Ministry of Road Transport and Bridges
 Bangladesh Bridge Authority
 Technical Wing, Design-2 Section
 Setu Bhaban, Banani, Dhaka-1212
 www.bba.gov.bd

Pre-Tender Meeting Minutes on BBA Work Package: WR-005/2025-2026, Name: 'Renovation, Widening and Strengthening of Jamuna Bridge Deck and Associated Works for Appropriate Use of Abandoned Rail Line during the FY 2025-2026'

Addendum-1 of Tender Document

Plan of the First Floor 1:150
Construction area of this floor: 1402.53 sqm (Approx.)

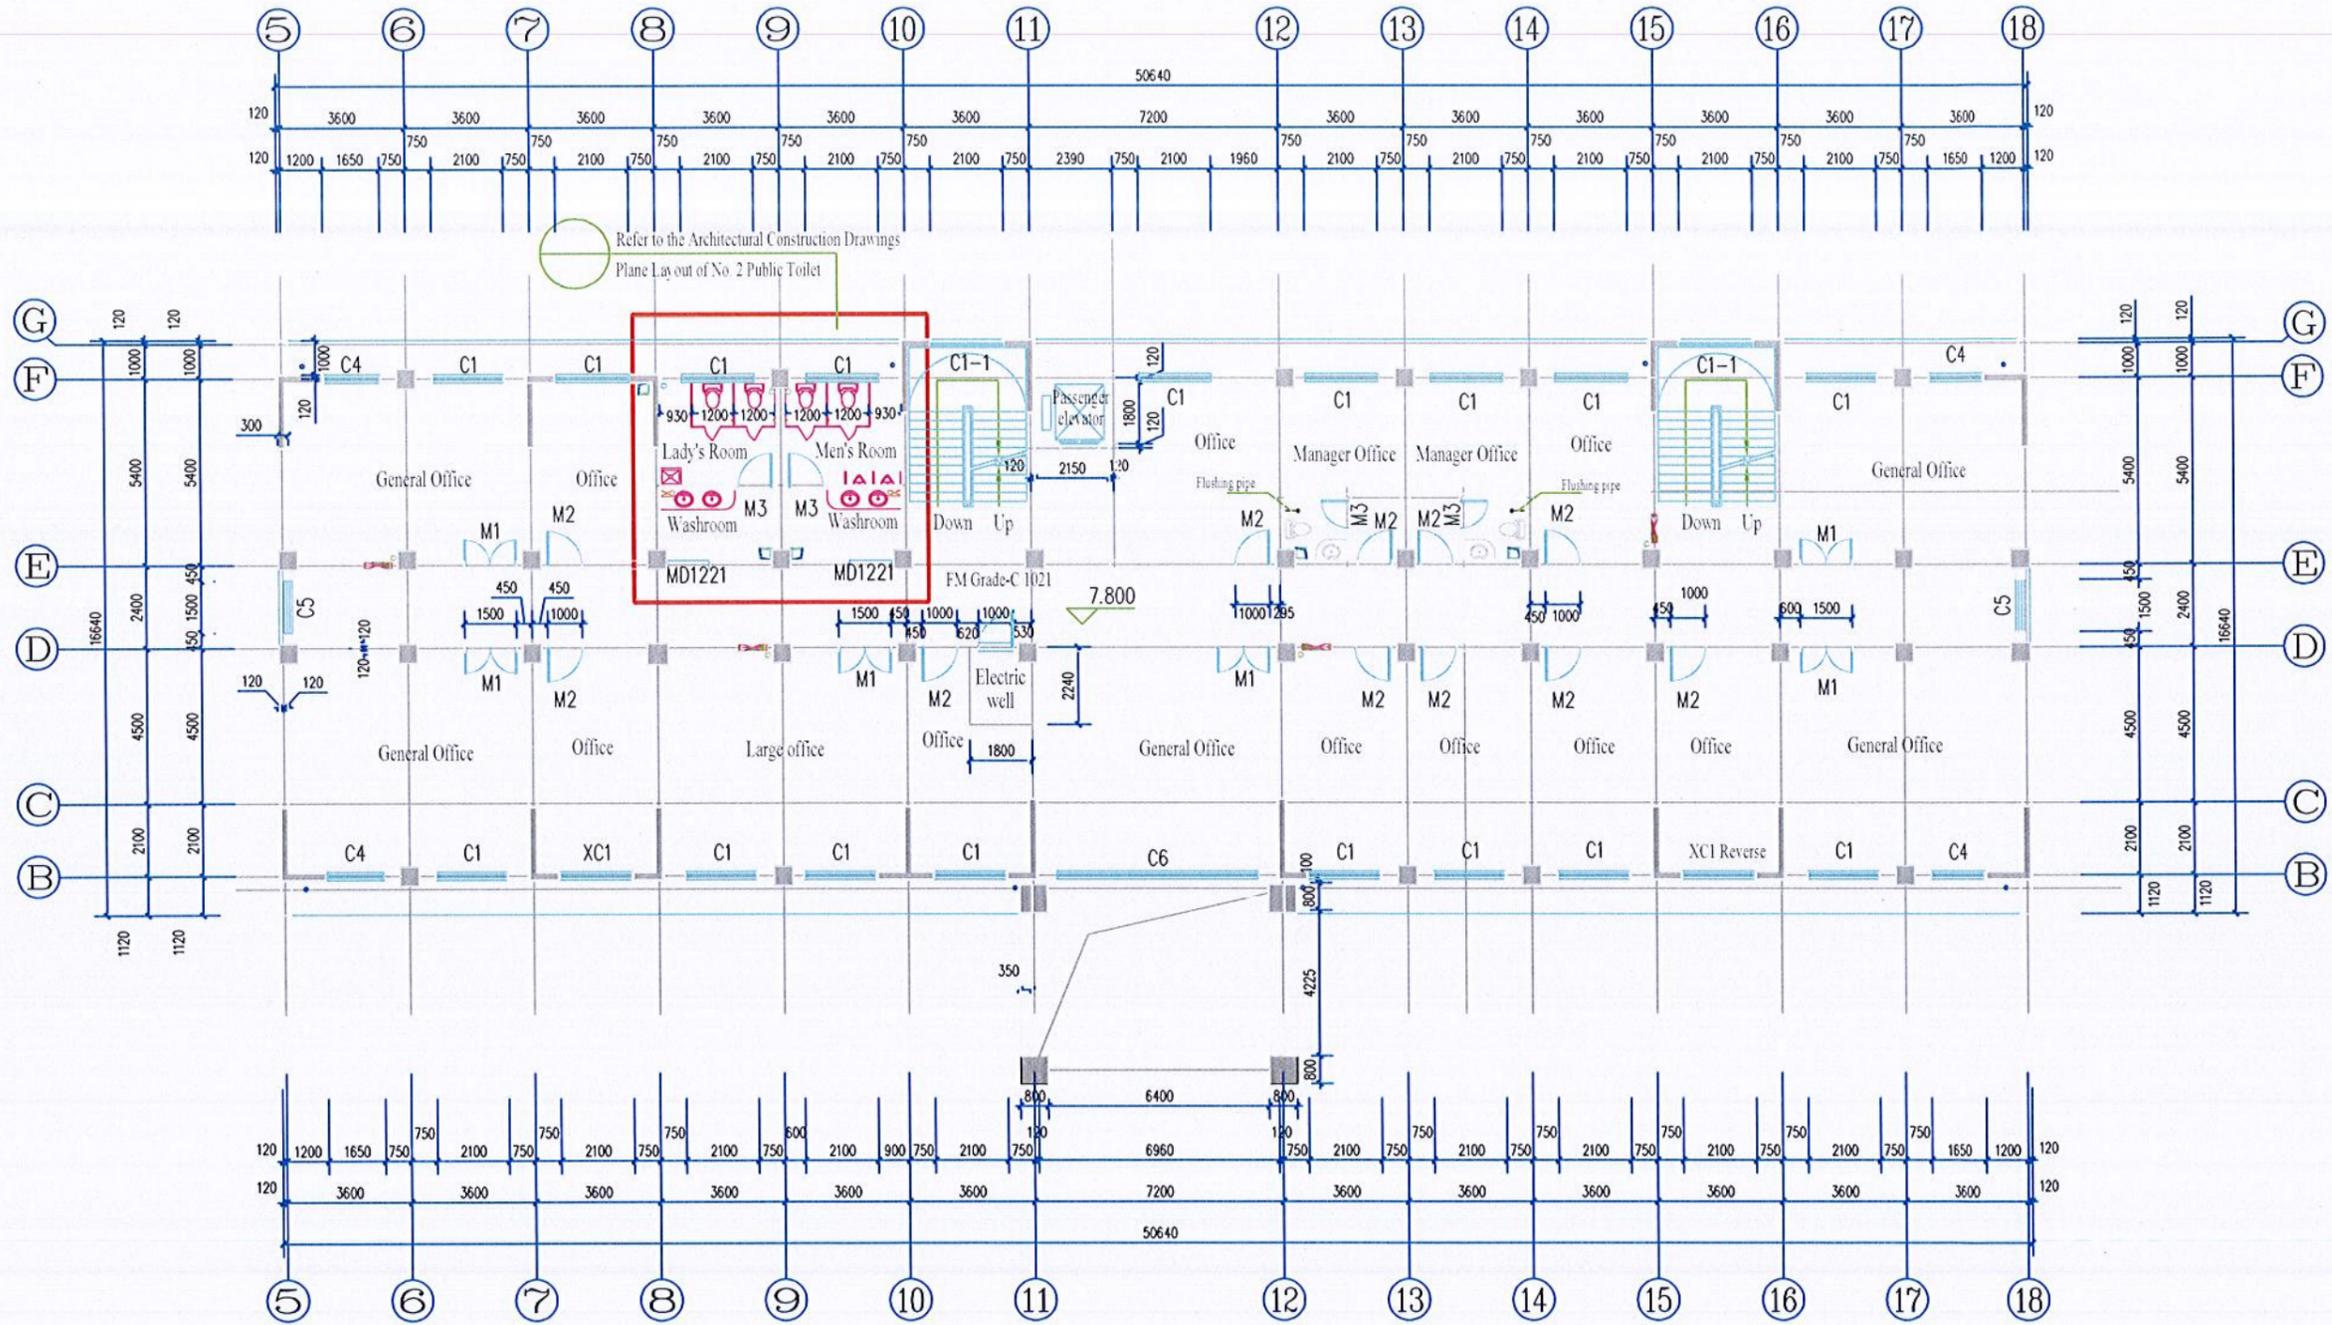
The width of the squat toilets was changed to 1.2m, and one of each type was removed.

Two manager's offices will have an additional 1800 x 2100 square meter restroom.

Plan of the Second Floor
 1:150
 Construction area of this floor: 848.76 sqm (Approx.)

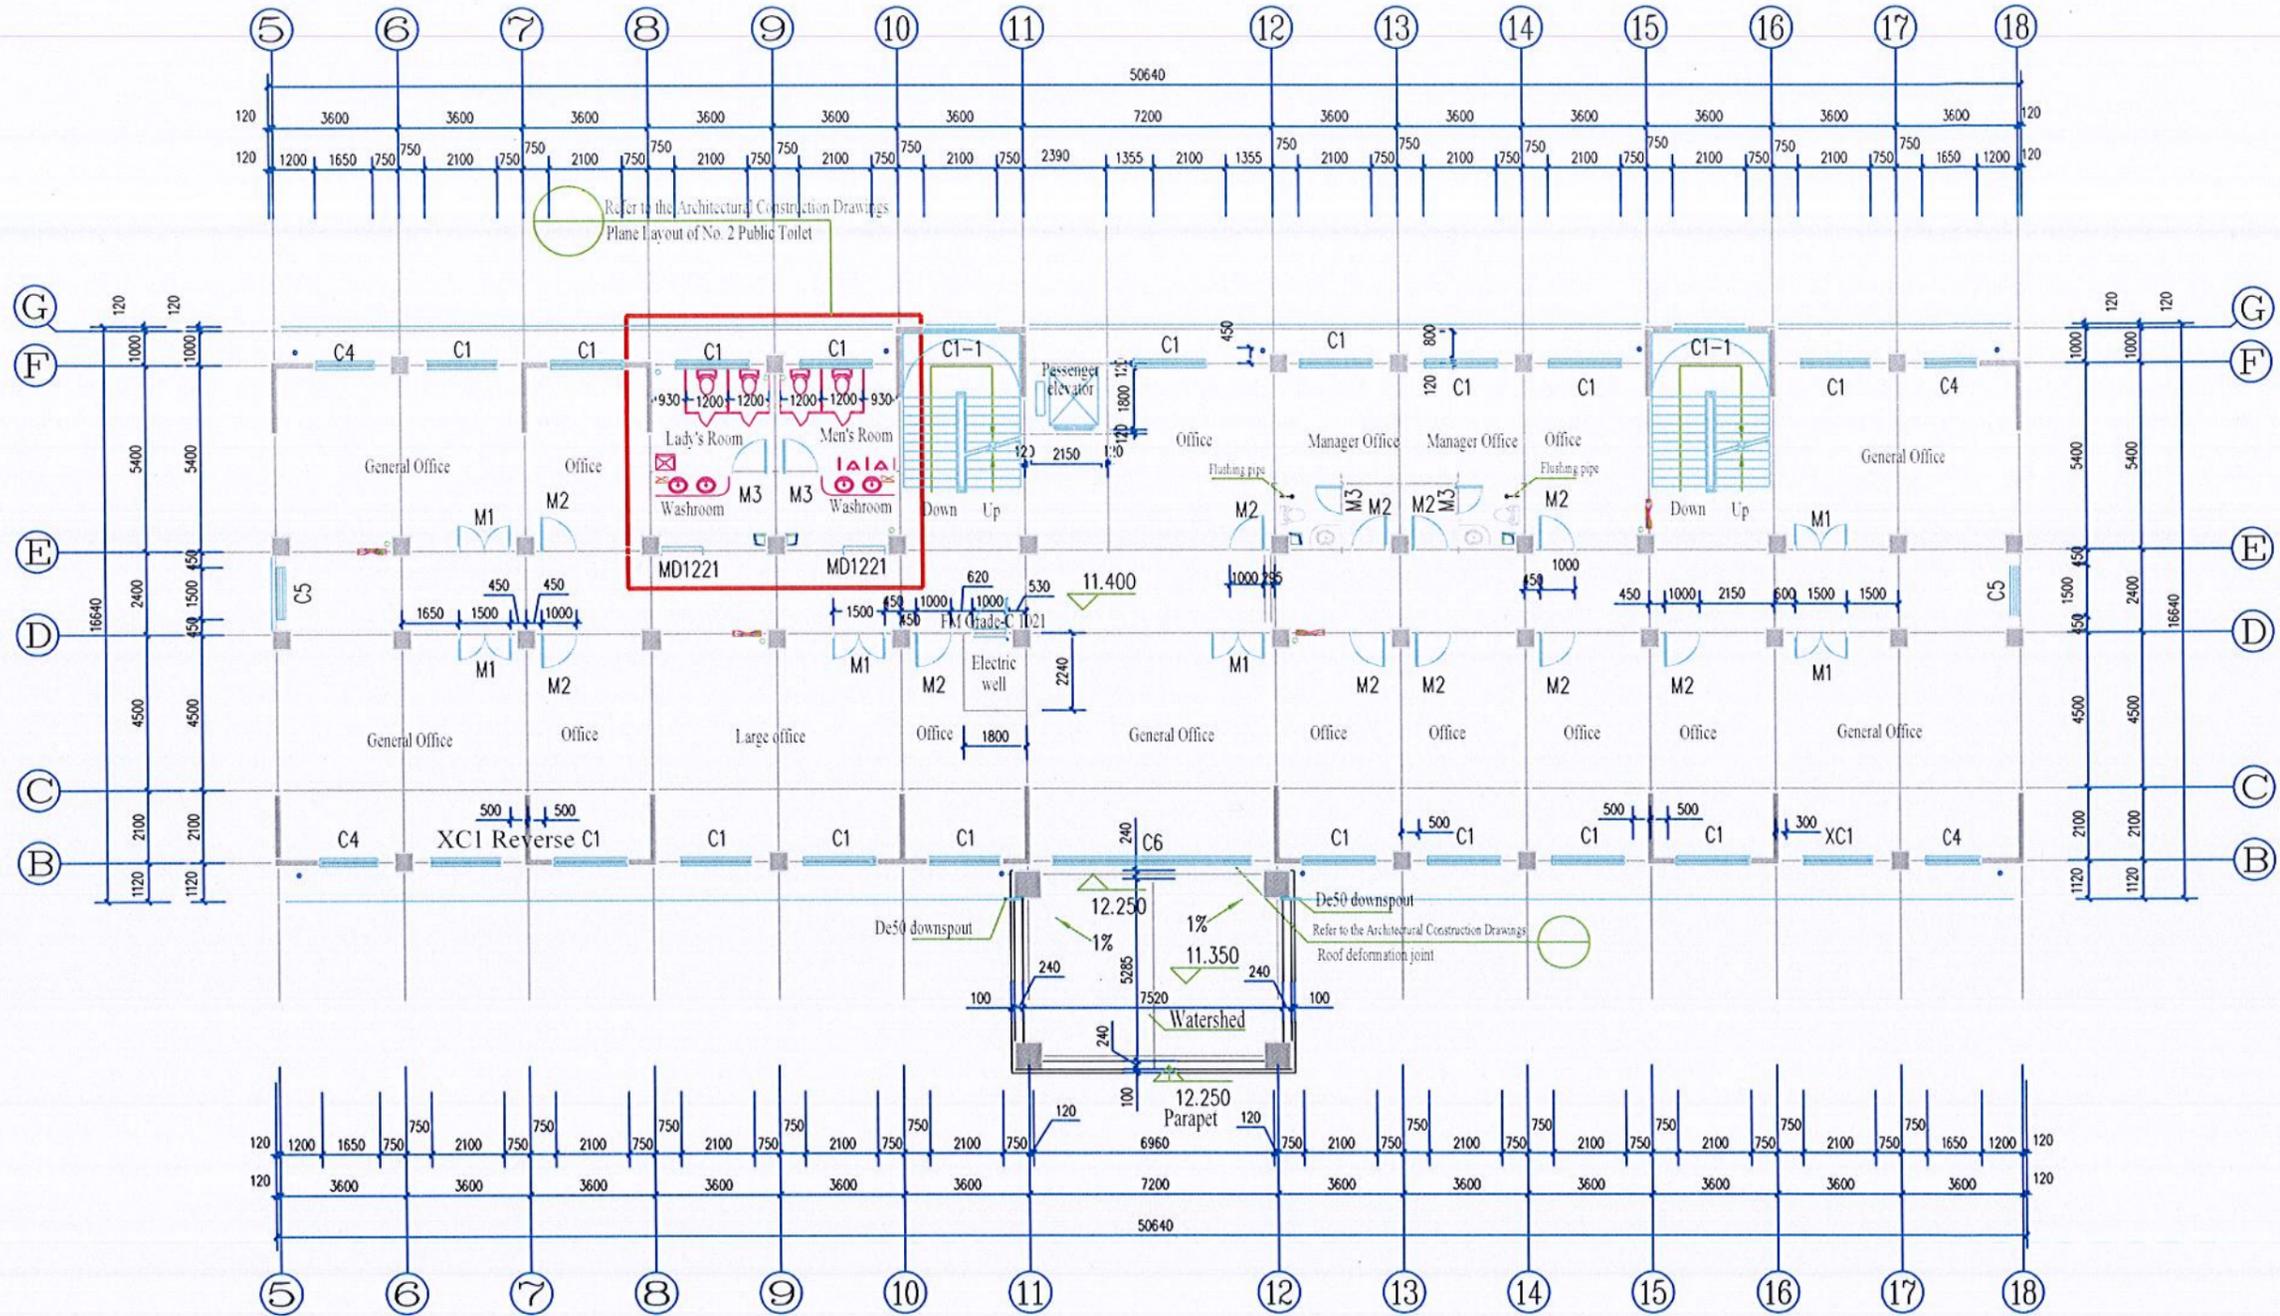
The width of the squat toilets was changed to 1.2m, and one of each type was removed.

Two manager's offices will have an additional 1800x1800 bathroom.
